Modification Recommended Service Note

Supersedes:
MSOS254A-03E

MSOS254A – MSO Infiniium S Series 2.5GHz 4 channel

Serial Numbers: MY00000001 - MY58060101; SG55510101, SG57130101, SG57220101

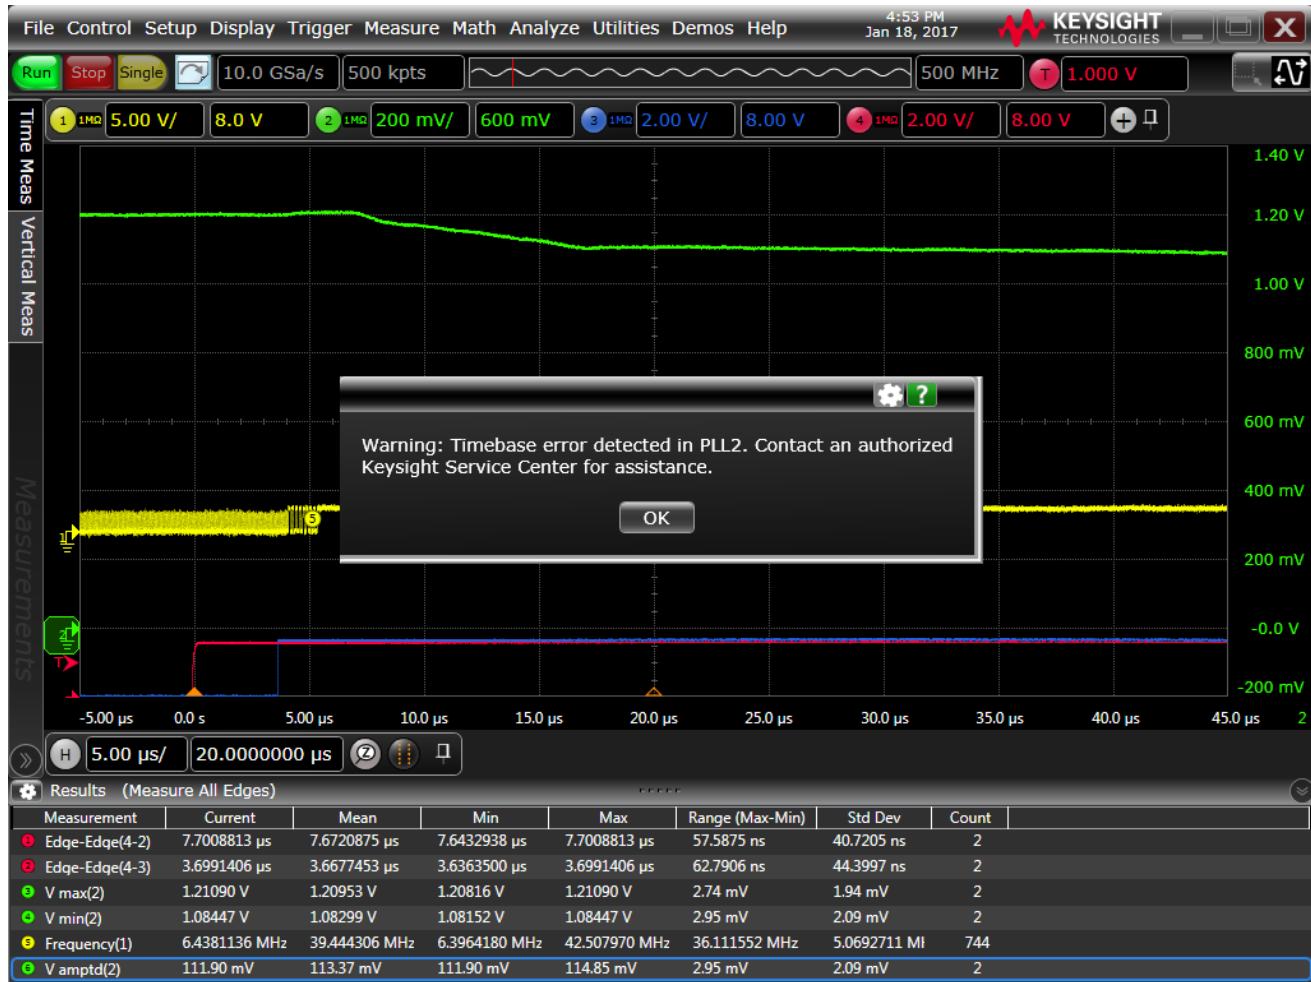
On older acquisition boards a PLL2 error message sometimes occurs. The error message appears on the screen as below:

There are new acquisition boards that fix this issue for the S-series scopes.

Please, use the 54911-69511 board until is gone.

If you have a 54911-69511, then skip steps 1 and 2 and proceed to step 3.

If there are no 54911-69511, then start with step 1 below.

1. If the customer needs to have software revision < 6.10.01001, then replace the acquisition board with the 54911-69532 board.
2. If the customer can have software revision \geq 6.10.01001, then it can be replaced by any of these three boards: 54911-69521, 54911-69531, or 54911-69532.
